# TECHNICAL BULLETIN LTB00241NAS5 05 MAR 2013

Front Suspension 'Knock' Noise Improvement

Range Rover Sport (LS) - with Model Year: 2007-2011

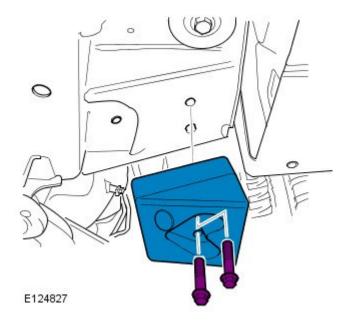
- **4.** If no mass absorber is installed, install the mass absorber.
  - Clean the underside of the second body mount carrier (located slightly rearward of the front wheel) to remove any contamination.
  - Install a mass absorber to the second body mount carrier using the two bolts per mass absorber provided in the mass absorber kit. Keep the lower face of the mass absorber parallel with the ground.
  - Tighten bolts to 115 Nm (85 lbf ft).

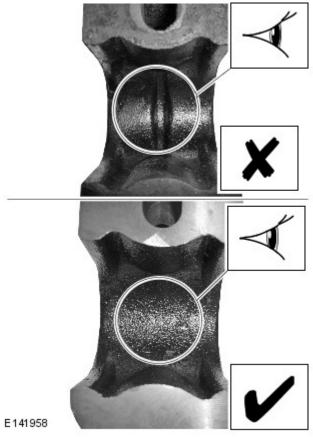
- **5.** If required, carry out steps 2-4 to the opposite side of the vehicle.
- **6.** Remove the front stabilizer bar bushing (TOPIx Workshop Manual section 204-06).
  - Inspect the Dynamic Response™ bush clamps.
  - If the old-design Dynamic Response™ bush clamps are installed (with internal ridge), discard the Dynamic Response™ bush clamps and install the new-design Dynamic Response™ bush clamps (no internal ridge) in step 8.
  - If the new-design Dynamic Response<sup>™</sup> bush clamps are installed (no internal ridge), re-use the Dynamic Response<sup>™</sup> bush clamps in step 8.
